Development Application Comments Report

Date:	March 6, 2019	# OF PAGES: # 10
To:	Jonathan Sprawson, Design Quorum Inc.	E: jon@dqi.ca
cc:	Elizabeth & Jim Knowlton, Owners	E: jim@masterhomes.org
From:	Melissa Dalrymple, Planner, Planning Services Dept	
Contact Info:	T: 905-845-6601 ext. 3297 F: 905-338-4414 E: melissa.dalrymple@oakville.ca	
Re:	Zoning Amendment Circulation Comments (1st submission)	
Application:	Private Residence	
Description:	Zoning By-law Amendment is to allow a Special Provision to permit semi-detached dwellings as a permitted use and to permit site specific regulations to accommodate the proposed site layout.	
Address:	79 Wilson Street	
Site Plan File #:	ZBA. 1715.23

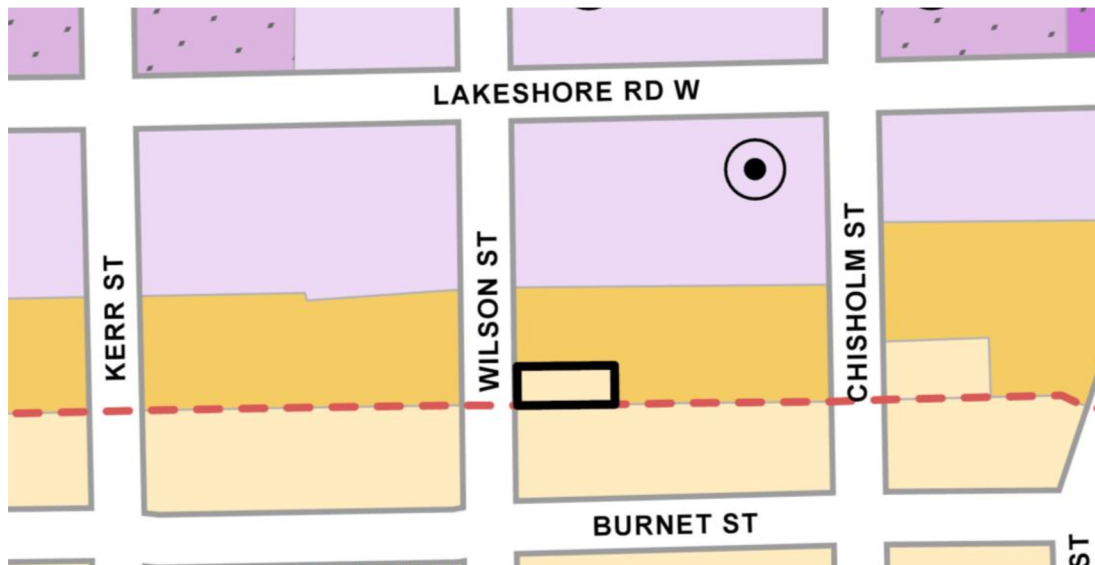
The Planning Justification Report submitted in support of the application indicates the subject lands are designated Medium Density Residential. This is not the case, the lands are designated Low Density Residential, as shown:

The development would yield the equivalent density of 54 units per hectare, which falls within high density residential density range (51 to 185 units per site hectare) as defined by Livable Oakville. With respect to numerical requirements of the plan, Part F – Implementation and Interpretation states:

The Planning Justification Report must be updated, to address the Low Density Residential designation, requested density and that the general intent of Livable Oakville is being maintained.
